Project Title:	Wyvols Court Farm
Project No/ Document Reference:	HD215-R004
Date:	29 April 2026
Author:	Andrew Lovegrove / Nick Billingham

RESPONSE TO WOKINGHAM BOROUGH COUNCIL HIGHWAY COMMENTS

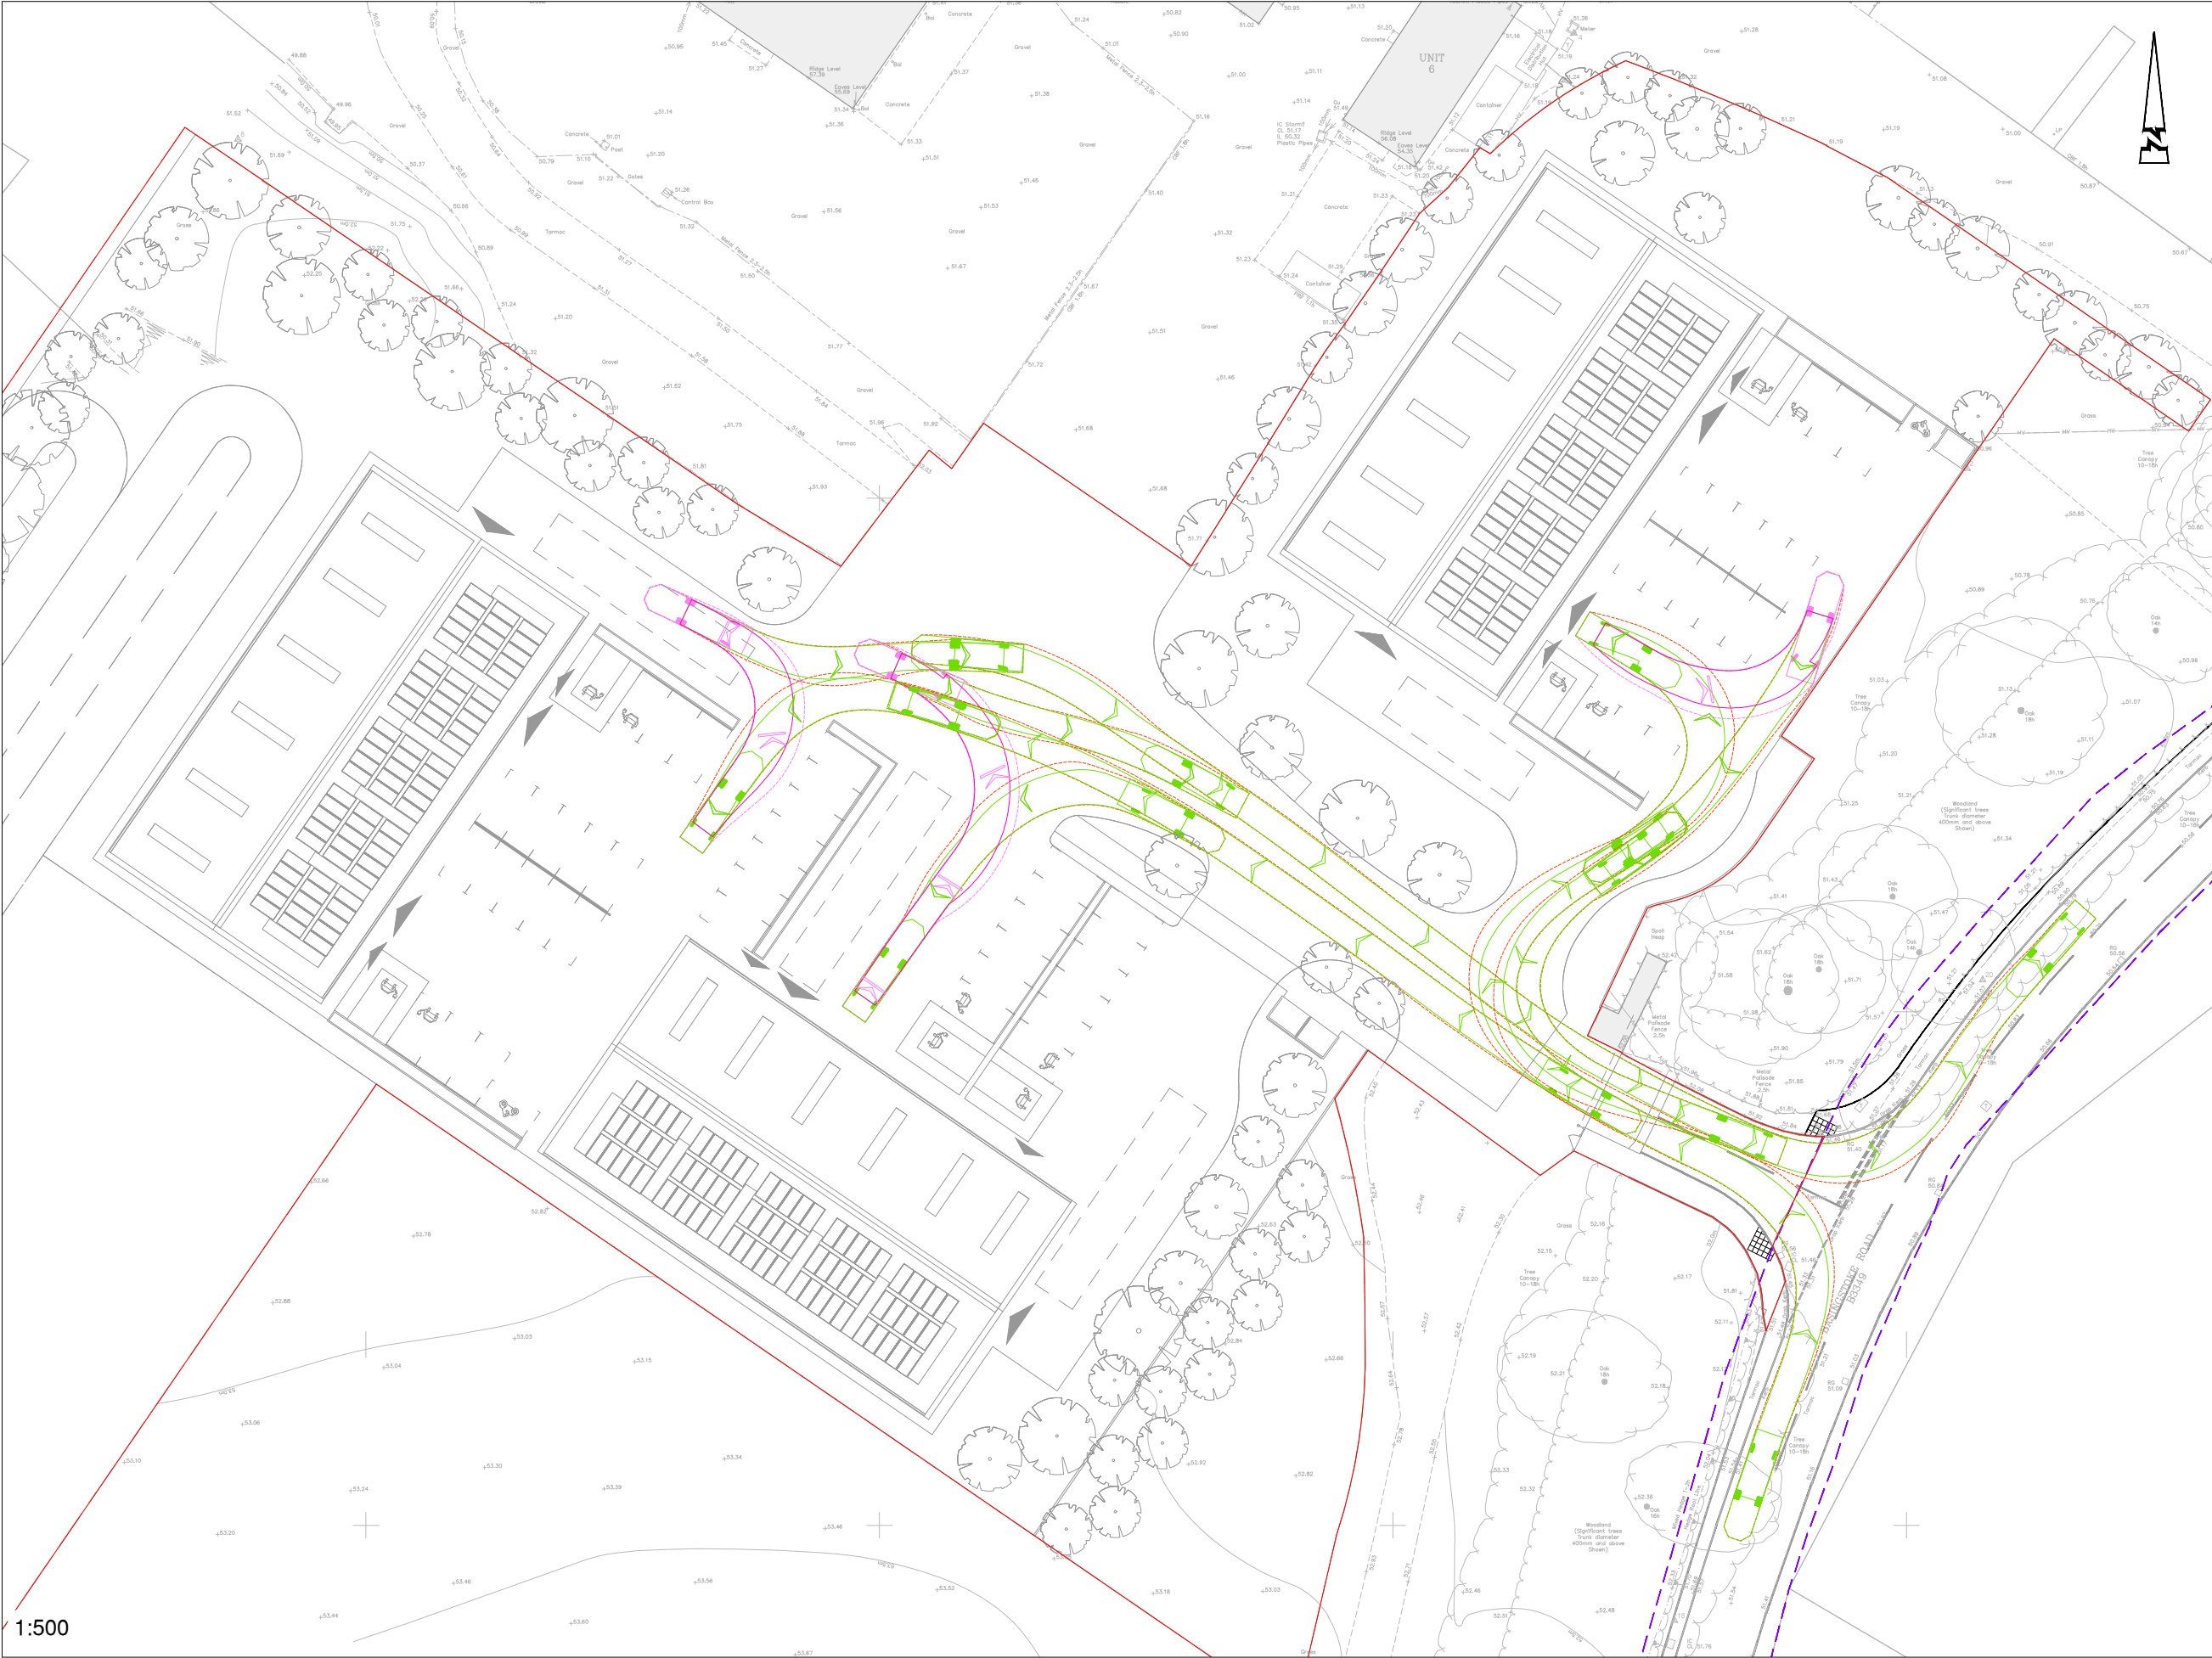
- It is, uncertain if the proposed widening of footway to the north of the access will be 2m wide throughout. The applicant is advised to submit an overview drawing for the general arrangement of the proposed access and off-site improvement works.

- There is no continuous pedestrian network between the site access and the existing public footway to the north of the access. The Highways are uncertain if the proposed off-site footway improvement can enhance the continuity and safety of proposed route to the bus stops. The applicant may wish to consider providing 2m wide footway on the northern side / both sides of the access.

- The applicant is expected to measure the intervisibility at the proposed crossing point on both sides of the B3349 Basingstoke Road along the tangent of the bend. Revision is required.

- 1.6.1 A summary of the WBC Highways comments relating to the proposed pedestrian crossing visibility splays has been summarised in the bullets below:
- Off-site footway improvement works is proposed in Drawing No. HD215-SK004. However, the proposed pedestrian visibility has not been assessed properly on both sides of the B3349 Basingstoke Road, in particular when the proposed crossing point is located within 20m of two junctions and HGV traffic are anticipated from the site.
 - The minimum SSD required for northbound is 60m (for 85th percentile speed of 37.7mph). The sightlines shall be across land within the applicant's control or highway land.
 - Meanwhile, the applicant is expected to measure the intervisibility at the proposed crossing point on both sides of the B3349 Basingstoke Road along the tangent of the bend. Revision is required.

It is, however, uncertain if the proposed widening of footway to the north of the access will be 2m wide throughout. The applicant is advised to submit an overview drawing for the general arrangement of the proposed access and off-site improvement works.

However, there is no continuous pedestrian network between the site access and the existing public footway to the north of the access. The Highways are uncertain if the proposed off-site footway improvement can enhance the continuity and safety of proposed route to the bus stops. The applicant may wish to consider providing 2m wide footway on the northern side / both sides of the access.

Off-site footway improvement works is proposed in Drawing No. HD215-SK-004. However, the proposed pedestrian visibility has not been assessed properly on both sides of the B3349 Basingstoke Road, in particular when the proposed crossing point is located within 20m of two junctions and HGV traffic are anticipated from the site.

The minimum SSD required for northbound is 60m (for 85th percentile speed of 37.7mph). The sightlines shall be across land within the applicant's control or highway land.

Meanwhile, the applicant is expected to measure the intervisibility at the proposed crossing point on both sides of the B3349 Basingstoke Road along the tangent of the bend. Revision is required.

- 1.3.2 As confirmation, no kerb line changes have been proposed to the existing access which will serve both the existing and new additional units. The required visibility for the existing access of 2.4m x 120m is fully achieved within the adopted highway boundary and does not extend into 3rd party land. This is demonstrated within drawing **HD215-001 B** included within **Appendix B**.

- 1.4.2 The proposed footway to the north of the B3349 has been designed as a continuous width of 2.0m. This provides a route from the site access to the proposed pedestrian crossing allowing users to safely reach the pedestrian infrastructure along The Street without having to walk via any non-pedestrian infrastructure. Drawing **HD215-001 B** has been revised to show the full extents of the footway.

- 1.4.3 Tactile paving is proposed at the current site access to allow a continuous movement between the existing footway to the south of the site and the new proposed footway. This additional measure will increase the usability of the footway for any visually impaired users in line with the inclusive mobility guidance.

- 1.4.4 Drawing **HD205-001 B** has been revised with updated pedestrian visibility splays along the B3349 for the proposed pedestrian crossing. The SSD used is based on the 85th percentile speed with 60m to the south and 58m to the north. An RSA 1 will be commissioned and submitted in due course.

- 1.6.2 The pedestrian visibility splays have been revised in drawing **HD215-001 B**. The SSD to the north is 58m and to the south 60m which is based on the 85th percentile speed recorded in the traffic surveys.
- 1.6.3 While the crossing lies 20m from the nearest junction, sightlines from the crossing to the junction are fully unobstructed and due to the low volume of pedestrians anticipated, the location of the crossing is deemed as acceptable.

Title
**SWEPT PATH ANALYSIS
FIRE TENDER**

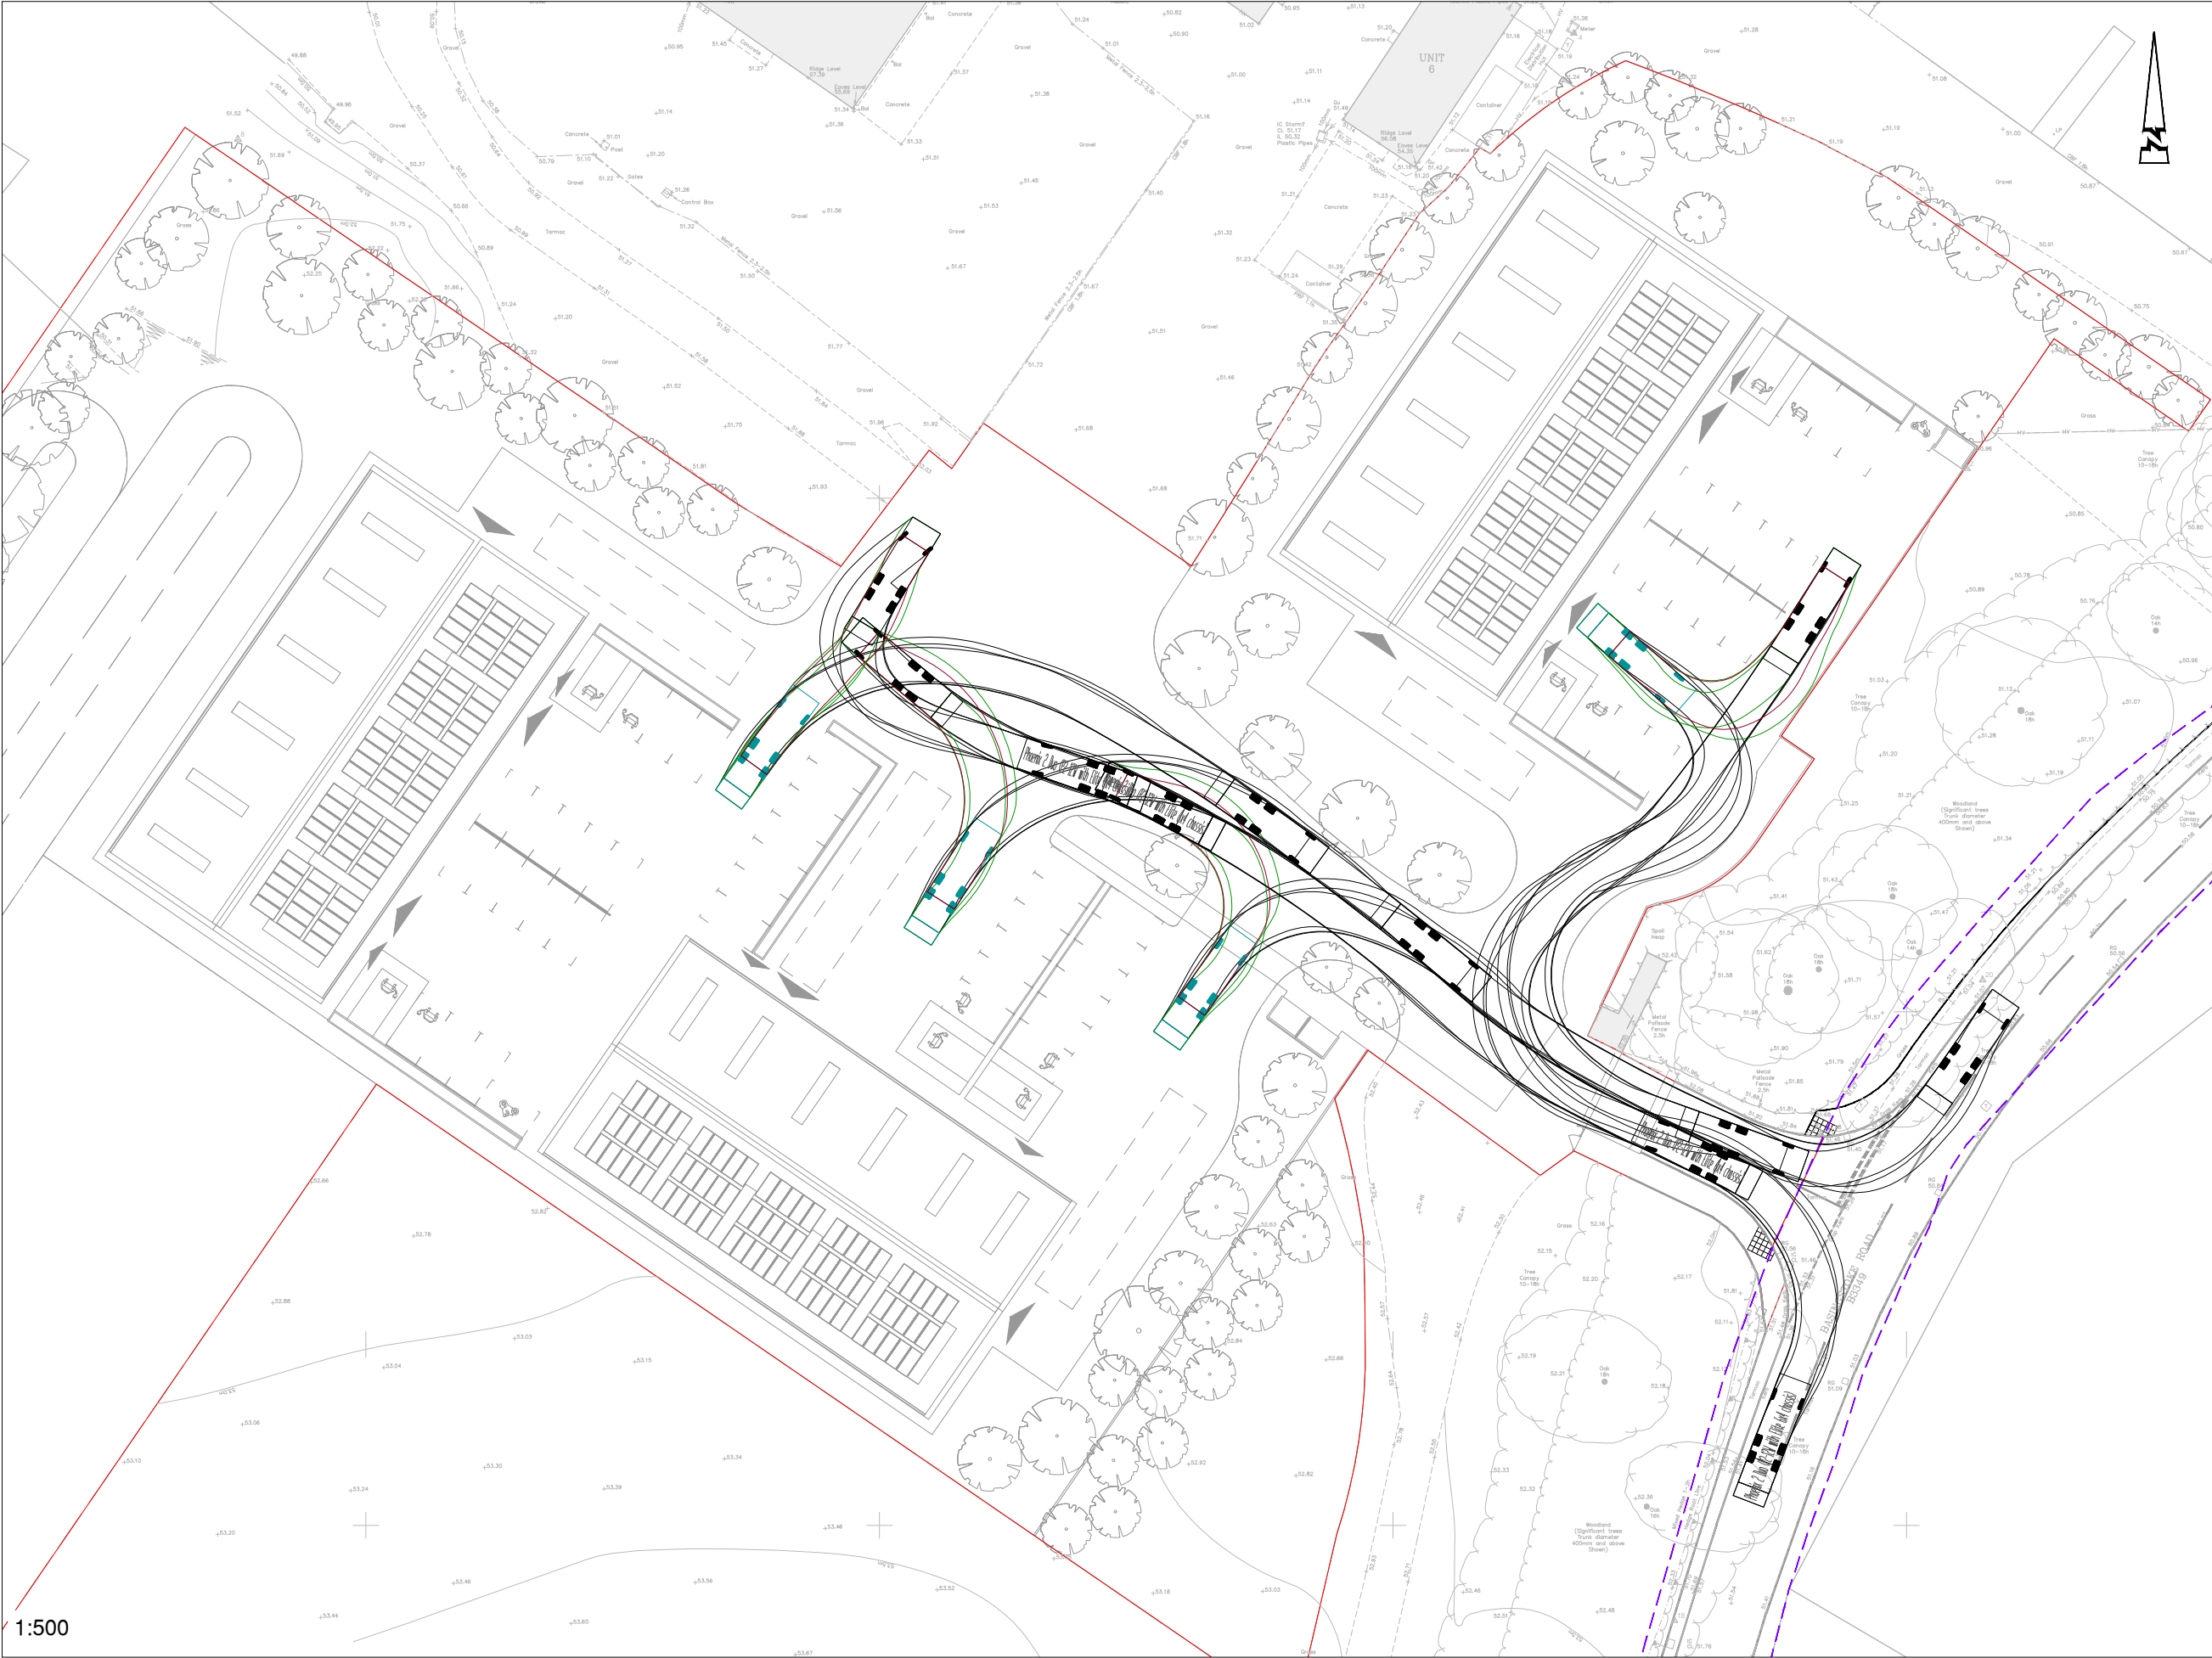
- The applicant is expected to demonstrate the manoeuvring of a fire tender vehicle entering and leaving the site access in forward gear to within 40m reach to the furthest point of the buildings. The council has adopted the following dimensions for fire tenders:

The applicant is expected to demonstrate the manoeuvring of a fire tender vehicle entering and leaving the site access in forward gear to within 40m reach to the furthest point of the buildings. The council has adopted the following dimensions for fire tenders:

- 1.8.2 Drawing **HD215-002 A** included within **Appendix C** demonstrates that a fire tender can access each plot with 30m from the entrance of each unit. Buildings will be fitted with relevant fire suppression and hydrants to conform to requirements.
